# *LEAF APARTMENTS*

**SE DESIGN REVIEW BOARD**

**RECOMMENDATION MEETING #2**

DPD # 3018098

## REQUEST FOR DEPARTURE - STREET LEVEL USES

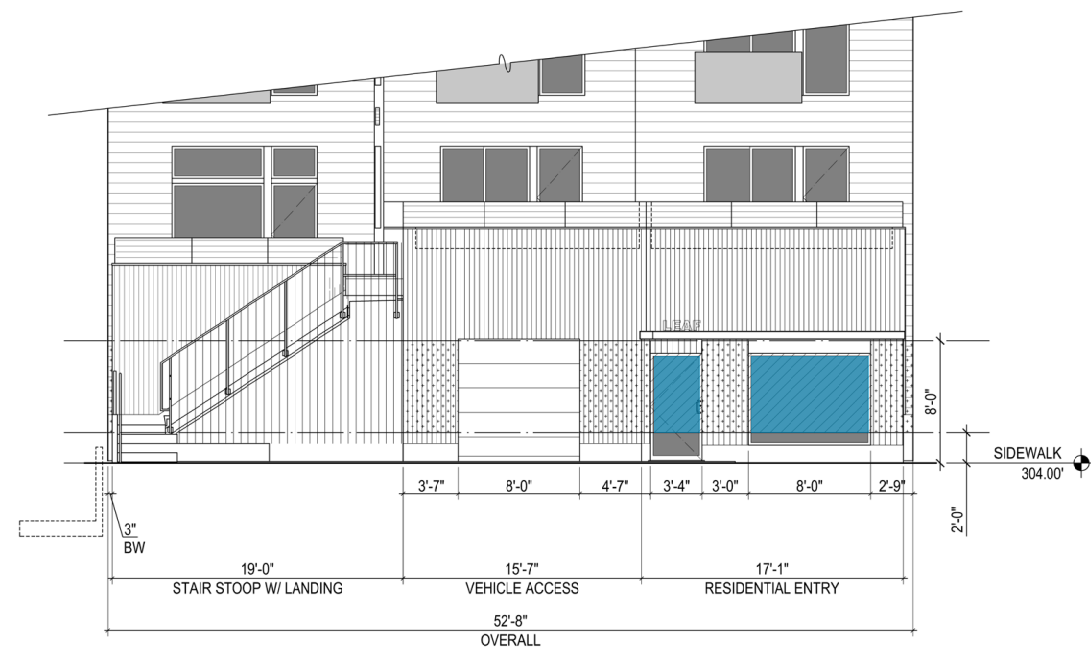
- BEACON AVE S - The Board approved the departure if the residential and commercial entrances are further differentiated.
- ALAMO PL S - The Board approved the departure.

ALAMO PL S STREET LEVEL USES CALCS:  
 TOTAL STREET-FACING FACADE LENGTH: 52'-8"  
 STREET-LEVEL USES:  
 STAIR/STOOP TO PRIVATE DWELLING: 19'-0" OR 36%  
 PARKING ACCESS: 15'-7" OR 30% (EXEMPT PER SMC 23.47A.032.B.1.a)  
 RESIDENTIAL ENTRY: 17'-1" OR 32%

TOTAL RESIDENTIAL USES: 68% - DEPARTURE REQUEST **approved**

BEACON AVE S STREET LEVEL USES CALCS:  
 TOTAL STREET-FACING FACADE LENGTH: 54'-3"  
 STREET-LEVEL USES:  
 RESIDENTIAL LOBBY: 14'-7" OR 27%  
 COMMERCIAL: 39'-8" OR 73%

TOTAL RESIDENTIAL USES: 27% - DEPARTURE REQUEST

CODE	CODE REQUIREMENT	PROPOSED DEPARTURE	RATIONALE
SMC 23.47A.005.C.1.e STREET LEVEL USES	Residential uses may occupy no more than 20% of the street-level street-facing façade	<p>Beacon Ave: 27% (Residential Lobby)</p> <p>Alamo Pl S: 68% <b>approved</b></p> <p>(30% Parking Access per SMC 47A0.32.A.1.c , exempt from street-level requirement per 23.47A.032.B.1.a)</p>	<p>The Board recommended including an intervening use between the parking and Alamo Pl S. The Board suggested uses such as live-work units and/or the residential lobby, agreeing that retail may be difficult to sustain.</p> <p>In order to accomodate an intervening use between the parking and Alamo Pl S, the Board noted their support for departures related to non-residential street-level development standards.</p> <p>The proposed street-level uses on Alamo Pl S provide continuity with the existing residential character and scale of the street. There are no existing commercial spaces on Alamo Pl S.</p> <p>The primary Residential Lobby and required fire exit located on Beacon Ave S is as minimal in width as is feasible. As a result of the narrow site, the percentage of street-facing width is greater than 20%.</p>

## REQUEST FOR DEPARTURE - TRANSPARENCY

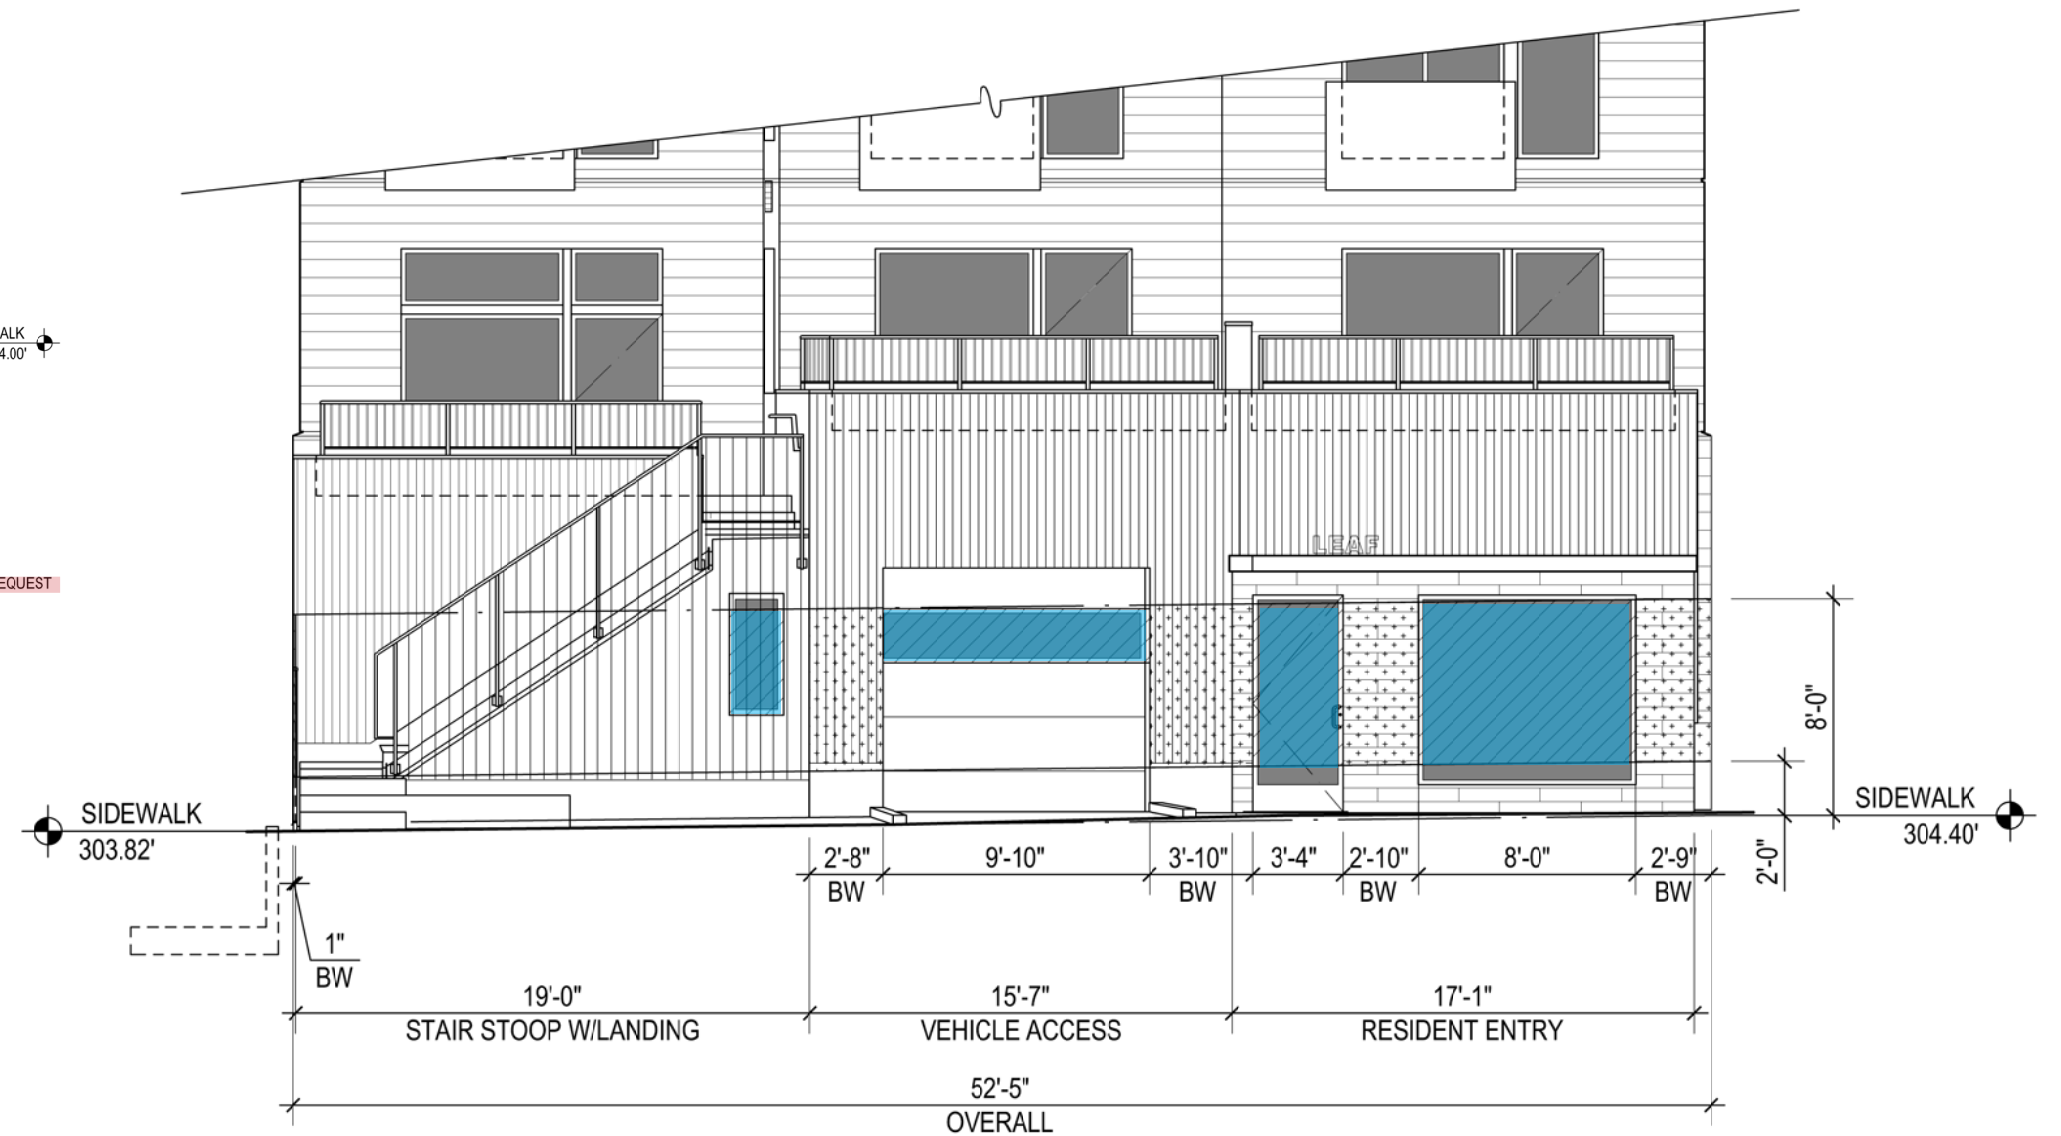
- The Board indicated support for a departure in order to accomodate uses along Alamo PI S, however, the departure as proposed was not supported. The Board found that an increase in transparency would better respond to the neighborhood context by providing a stronger connection to the street.

CURRENT DEPARTURE REQUEST

ALAMO PL TRANSPARENCY CALCS:  
TOTAL AREA CONSIDERED: 315 SF (FACADE BETWEEN 2' & 8' ABV GROUND)  
TOTAL OF TRANSPARENT AREAS: 95 SF OR 30% - DEPARTURE REQUEST

CODE	CODE REQUIREMENT	PROPOSED DEPARTURE	RATIONALE
SMC 23.47A.008.B.2 TRANSPARENCY	Sixty percent of the street-facing façade between 2 and 8 feet above the sidewalk shall be transparent.	Beacon Ave S: 62% (complies) Alamo PI S: 30%	Street uses on Alamo PI S include a stair to the private dwelling unit on Level 2, parking garage entry and a residential entry/lobby. Transparency is provided where possible and appropriate without creating light pollution from the parking garage. The stair/stoop erodes the massing at the NW corner lessening any blank wall effect and reinforcing the sculptural quality of the building base at street-level
